## **DEVELOPMENT CONTROL COMMITTEE**

#### Item 5; 2-4 Ringers Road and 5 Ethelbert Road, BR1 1HT (21/05585/FULL1).

**2-4 RINGS ROAD**  
**RESPONSE TO LLFA COMMENTS**

CLIENT:	Ringer Road Properties Ltd
PROJECT:	2-4 Ringer Road
DRAWING:	Outline SuDS

**20108-SWD-DP-01-C02**

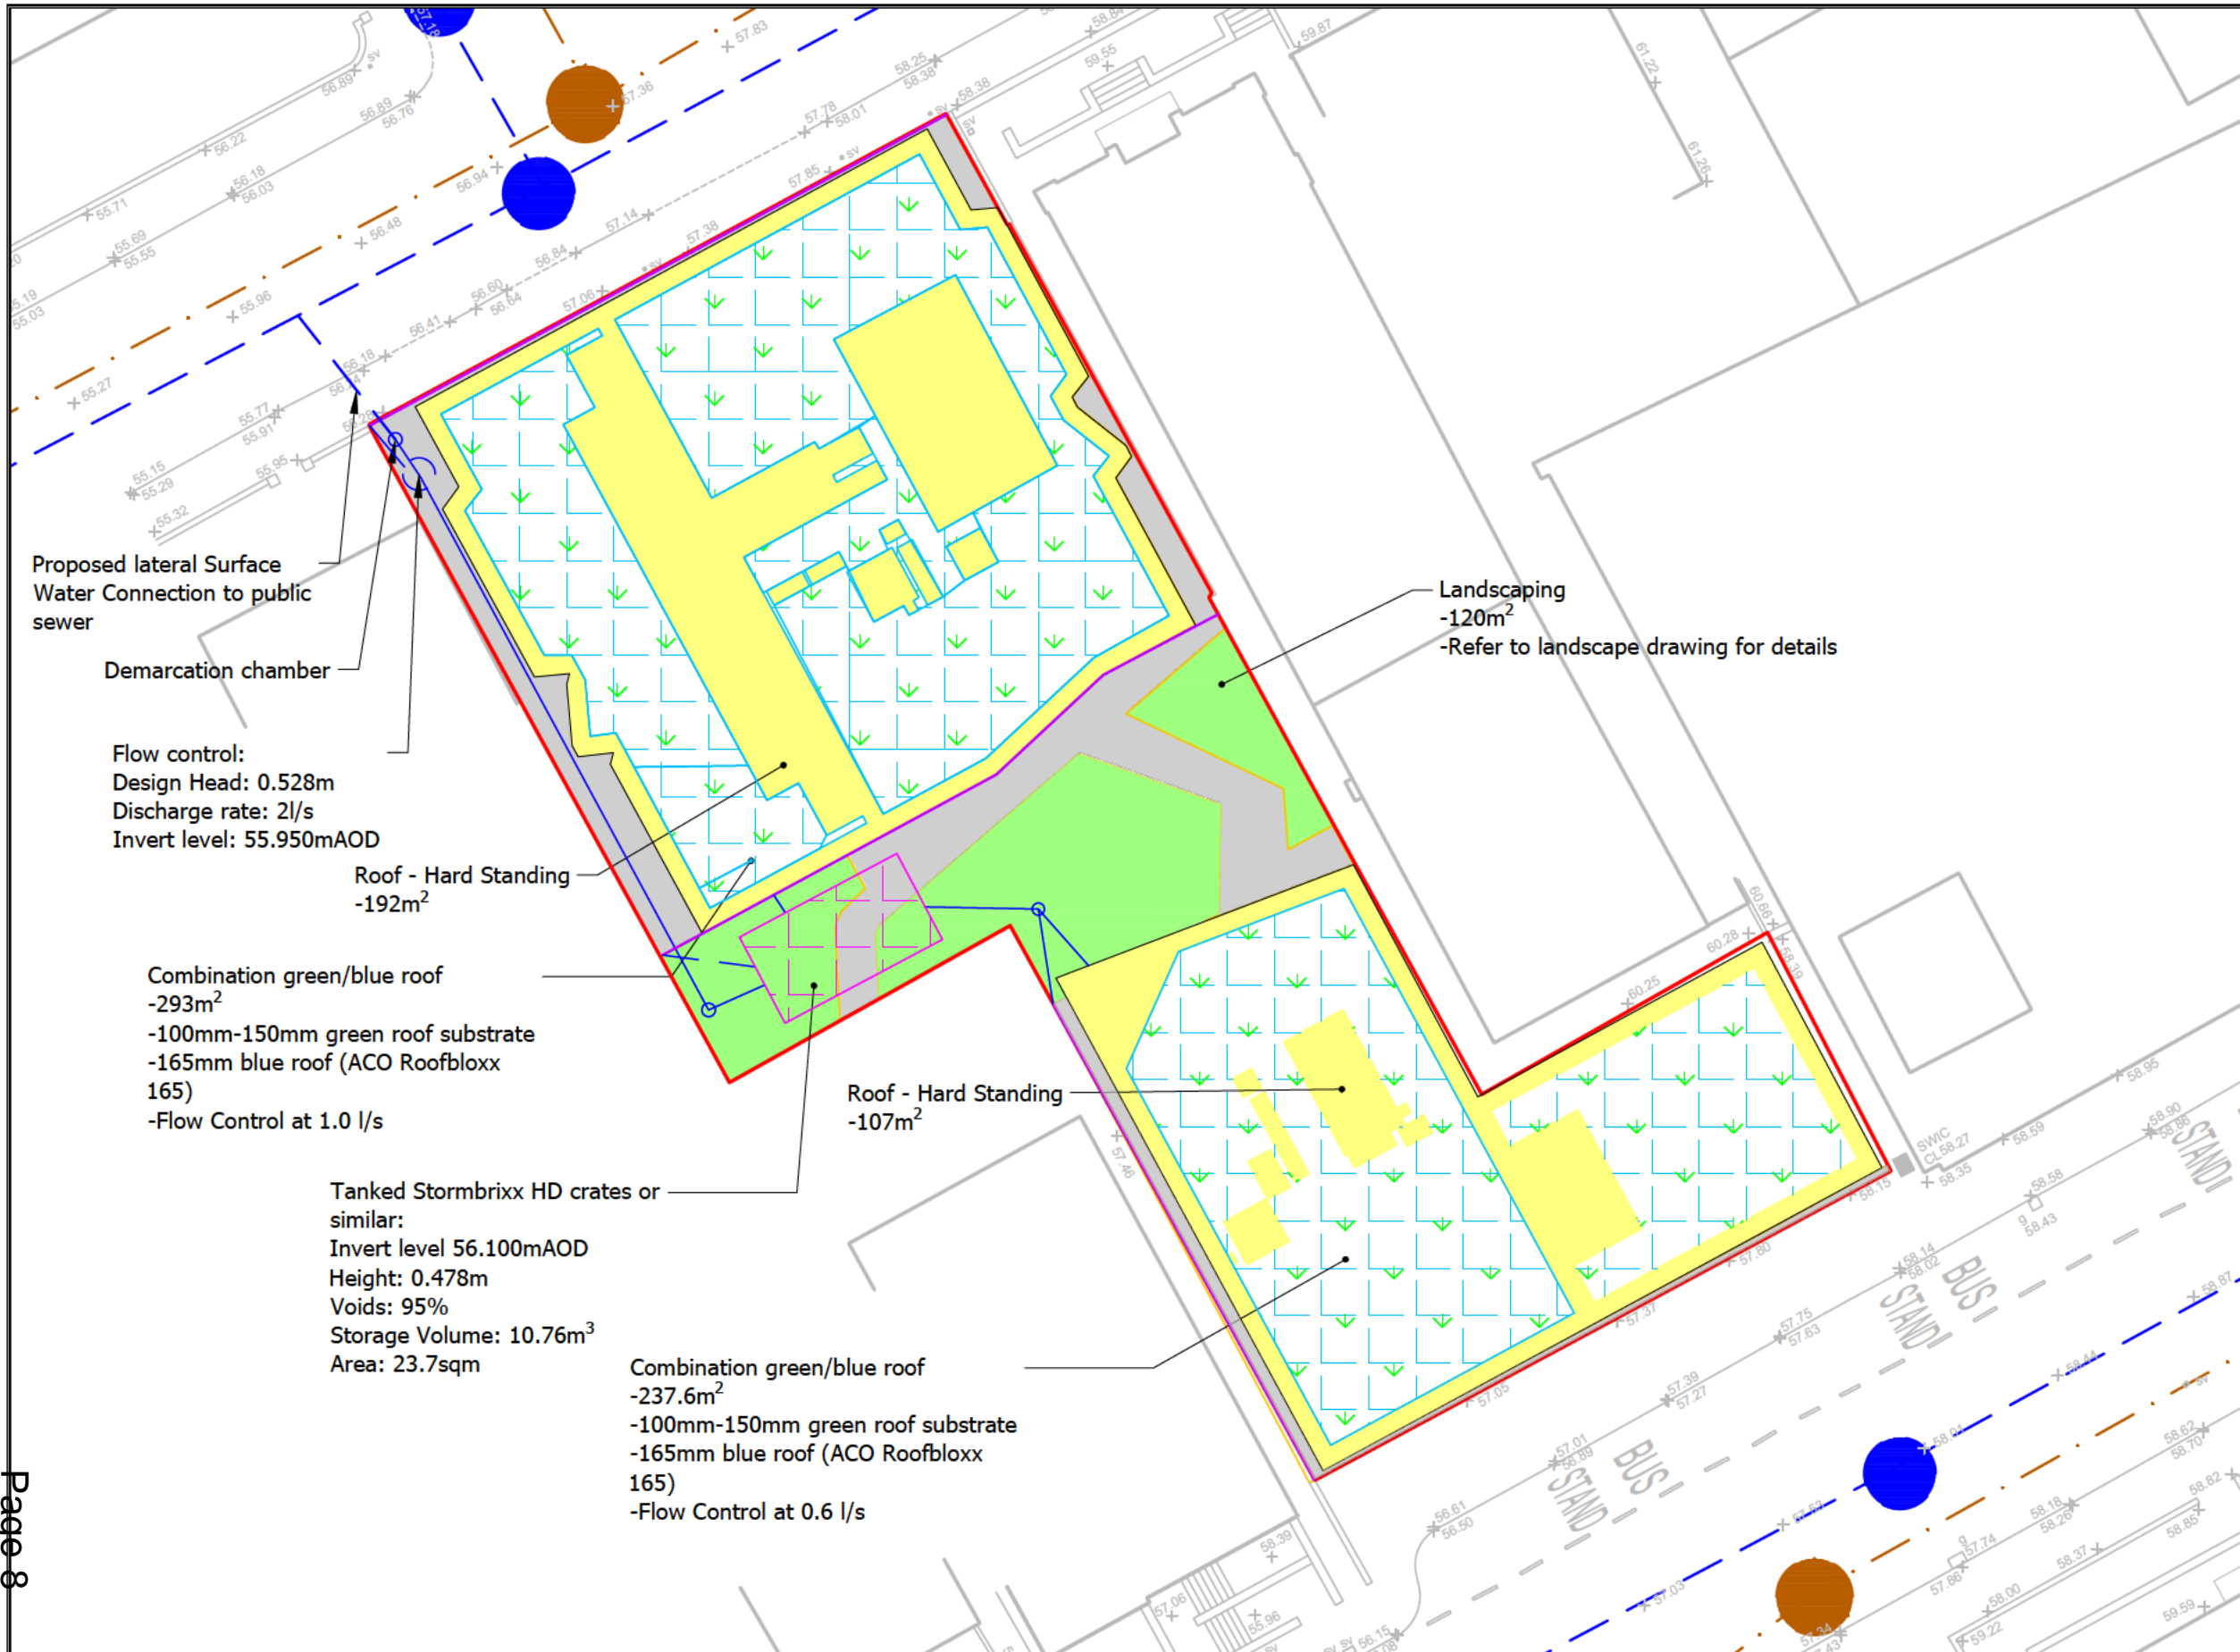
*"The acceptance of Thames Water of a discharge rate of 5l/s is subject to LLFA's approval of the sequential approach to the disposal of surface water. We consider in this case that the proposed discharge of 5l/s is high and would require the applicant to increase its storage volume to restrict the rate to maximum of 2l/s for all events including the 1 in 100 year plus 40% climate change. I do not accept the findings of the submitted FRA."*

Water Environment Ltd have revised the SuDS strategy for the site and incorporated an area of crated storage in the courtyard area. The strategy proposes a stormwater drainage discharge rate of 2 l/s from site, connecting to the existing Thames Water stormwater sewer in Ringer's Road.

CO2	27/11/23	Strategy amended following LLFA comments	AMG	TC
REV	DATE	AMENDMENTS	DR	AP
